Virgil C. Summer Nuclear Station (VCSNS) Units 2 and 3
Combined License Nos. NPF-93 and NPF-94
Docket Nos. 52-027 & 52-028

Subject: LAR 14-07 S1 License Amendment and Exemption Request: CA04 Structural Module ITAAC Dimensions Change

**SCE&G Response to NRC Request for Additional Information Letter No. 7749
(LAR 14-07 S1)**

**Update to License Amendment Request
CA04 Structural Module ITAAC Dimensions Change
(LAR 14-07 S1)**

Figure 1: Concrete Cross-Section between CA04 and CB65

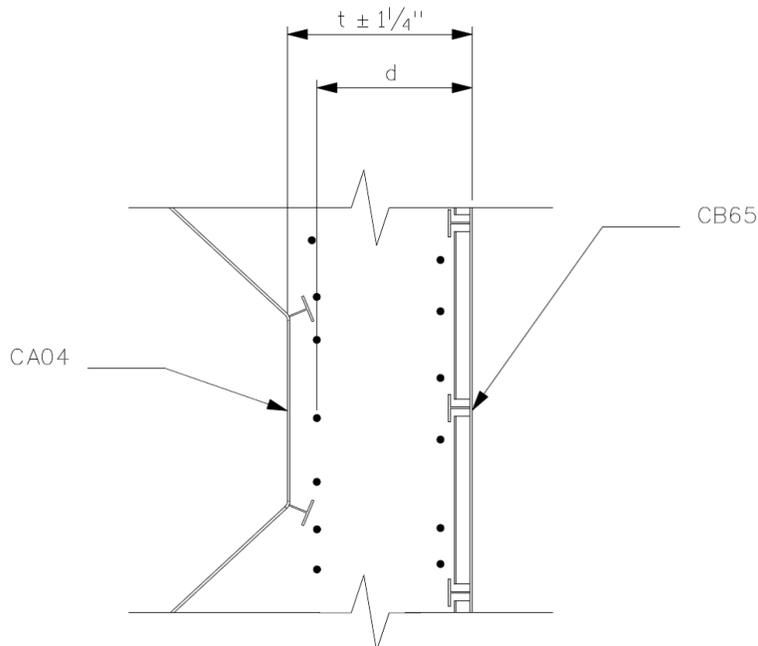
Question (26401):

On page 5 of 13 of the License Amendment Request (LAR 14-07), Enclosure 1, "License Amendment Request: CA04 Structural Module ITAAC Dimensions Change," the second paragraph states, "As stated in UFSAR Subsection 3.8.3.6.1, structural module tolerances conform to the requirements of section 4 of ACI117, Sections 3.3 and 3.4 of AWS D1.1, and Section 01.23 of AISC N690, and FSAR Subsection 3.8.4.4.1 requires that the design and analysis procedures are in accordance with ACI 349." The staff interprets this statement to indicate that the proposed tolerance changes for the structural modules meet the requirements in ACI 117. The staff noticed a difference between the tolerances in ACI 117 and the tolerances proposed in the LAR. ACI 117, Section 4.5, "Deviation from Cross-Sectional Dimensions," stipulates that the thickness of elements, except slabs, where specified cross-sectional dimension is more than 36 inches (3 feet), the tolerances is plus 1 (+1) and minus 3/4 (-3/4) of an inch. These values are different than those proposed in the LAR. The licensee is requested to modify the LAR, conveying the difference between the standard and the LAR proposed wall thickness tolerance or providing a technical justification that validates this statement.

The Tier 1 Table 3.3-1 tolerances apply to wall thickness ITAAC values and do not correspond to tolerances provided in ACI 117. Construction is performed in accordance with ACI 117, which specifies the tolerances on cross-sectional dimensions as +1 and -3/4 in. for dimensions over 3 ft. ITAAC measurements are performed relative to the acceptance criteria specified by Table 3.3-1. The tolerances in Table 3.3-1 are in some cases larger than those in ACI 117 and are appropriate for the corresponding ITAAC. The ITAAC in Tier 1 Table 3.3.6 Item 3.3.00.02a.II.a that references Table 3.3-1 does not verify that the Containment Internal Structure as-built structures are in conformance with ACI 117.

The proposed changes of the tolerances in table 3.3-1 of plant-specific DCD Tier 1 of LAR 14-07 (total CA04/CB65 wall tolerance of $\pm 1-1/4$ " and total CA04/CA01 wall tolerance of $\pm 1-5/8$ ") are greater than the values described in ACI 117. To determine the impact and the margin, an assessment was performed of the affected areas. Figure 1 depicts the CA04/CB65 cross-section and shows the d value which is the distance from the extreme compression fiber to the centroid of the rebar per ACI 349-01. The d value is the governing parameter for the design in regards of determining the rebar demand and spacing.

In Figure 1 the thickness of the wall and the proposed change requested in LAR 14-07 are shown. For evaluation of the impact and the margin of the wall design variation, the wall thickness and corresponding "d" value was set to $\pm 1\text{-}1/4\text{'}$, which is greater than ACI 117 tolerances on cross-sectional dimensions. For evaluation of the impact of the thickness differences between CA01 and CA04, the variation of the concrete thickness was set to $\pm 1\text{-}5/8\text{'}$. It should also be noted that the CA01/CA04 walls are 7'-6" to 9'-0" thick and designed as mass concrete.

As noted in the RAI UFSAR Subsection 3.8.3.6.1 is not consistent with the larger wall thickness tolerance. A proposed change to the LAR and UFSAR Subsection 3.8.3.6.1 is provided below to identify that some thickness tolerances may exceed ACI 117 tolerances. The proposed change clarifies that for walls around the reactor vessel cavity, the evaluation of the reinforcement design in the concrete conforms to the reinforcement design requirements of ACI 349.

Figure 1: Concrete Cross-Section between CA04 and CB65

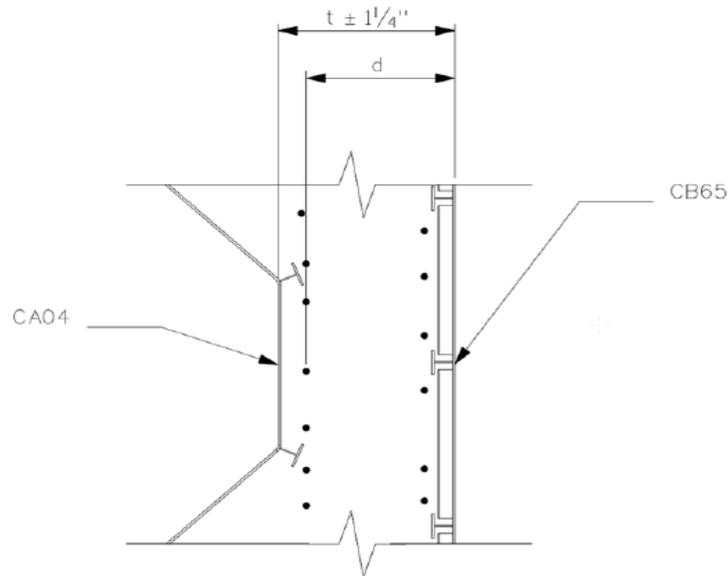
The proposed installation tolerance of $\pm 1\text{-}1/4"$ between the CA04/CB65 wall is greater than the $\pm 1"$ specified in ACI 349-01 Section 7.5.2.1 and the $+1\text{'}/\text{-}3/4"$ found in ACI 117. To determine the impact and the margin, an assessment was performed of the affected areas. Figure 1 depicts the CA04/CB65 cross-section and shows the d value which is the distance from the extreme compression fiber to the centroid of the rebar per ACI 349-01. The d value is the governing parameter for the design in regards of determining the rebar demand and spacing.

In Figure 1 the thickness of the wall and the proposed change requested in LAR 14-07 are shown. For evaluation of the impact and the margin of the wall design variation, the wall thickness and corresponding "d" value was set to +/- 1-1/4", which is greater than ACI 117 tolerances on cross-sectional dimensions. As a result of the assessment, it was found that the minimum margin for vertical reinforcement is 48.4%, for horizontal reinforcement 55.3% and for shear 61.3 %. Since the thickness of the wall influences also the d value, an assessment of the shear reinforcement spacing was performed which found the provided spacing sufficient. ~~To address this deviation, the total wall width was evaluated for both the larger and smaller tolerances from the actual design wall width of 36 inches. The review found that the required reinforcement in each direction increased slightly, but that the amount of reinforcement used in the wall design was still adequate.~~

Similarly, the CA04/CA01 walls were examined to determine the impact of the extra ±5/8" beyond the ACI 349-01 requirements and the 7/8" beyond the ACI 117 requirements. For evaluation of the impact of the thickness differences between CA01 and CA04 the variation of the concrete thickness was set to +/- 1-5/8". It should be noted that these walls are 7'-6" to 9'-0" thick and designed as mass concrete. ~~Code allowable tolerance,~~ This assessment conservatively assumed ~~ing~~ the worst case tolerances in all directions of the CA04 module instead of only the affected walls. The analysis found that there was a potential for a ~~minor,~~ ~~0.51.3%~~ decrease to the area of the surrounding concrete and that this ~~change in tolerance decrease has no significant impact on the in-place structural analyses or qualifications is insignificant and negligible.~~
